CITY OF ALBUQUERQUE

**RE: La-Z-Boy Center
Grading and Drainage Plan
Engineer's Stamp Date: 08/17/22
Hydrology File: E17D005**

Based upon the information provided in your submittal received 08/17/2022, the Grading & Drainage Plan is not approved for grading and paving permit until the following comments are addressed:

Sheet Title:
Hydrology Report

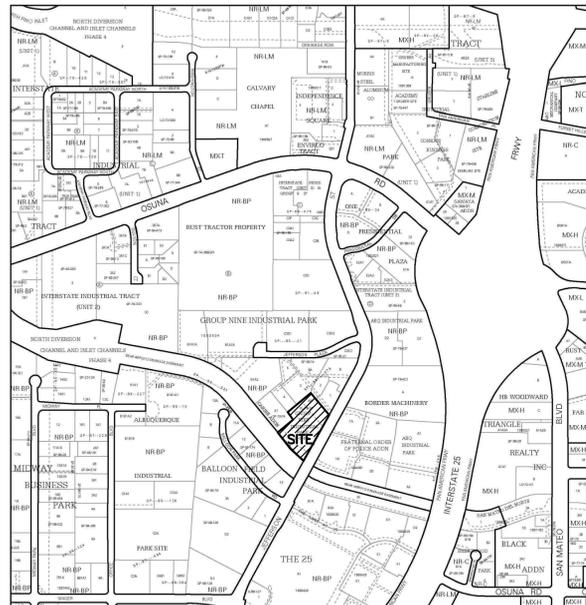
1. Provide for stormwater quality for the proposed impervious area: 0.26" of runoff. Hydrology realizes the area was previously impervious, but when construction is to occur on existing sites stormwater quality must be provided. A pond or similar can be built or the attached waiver can be filled-out and submitted
2. Since the site abuts the Bear Canyon Arroyo, AMAFCA approval is required prior to City approval. AMAFCA's requirements may affect the use of the waiver mentioned in paragraph 1.
3. Show the outfall from the site (inlet and pipe) to the arroyo and label the Bear Canyon Arroyo.
4. In the existing conditions paragraph, please state "The sites drains to the Bear Canyon Arroyo via an inlet in the southwest corner and a pipe into the arroyo" or similar.
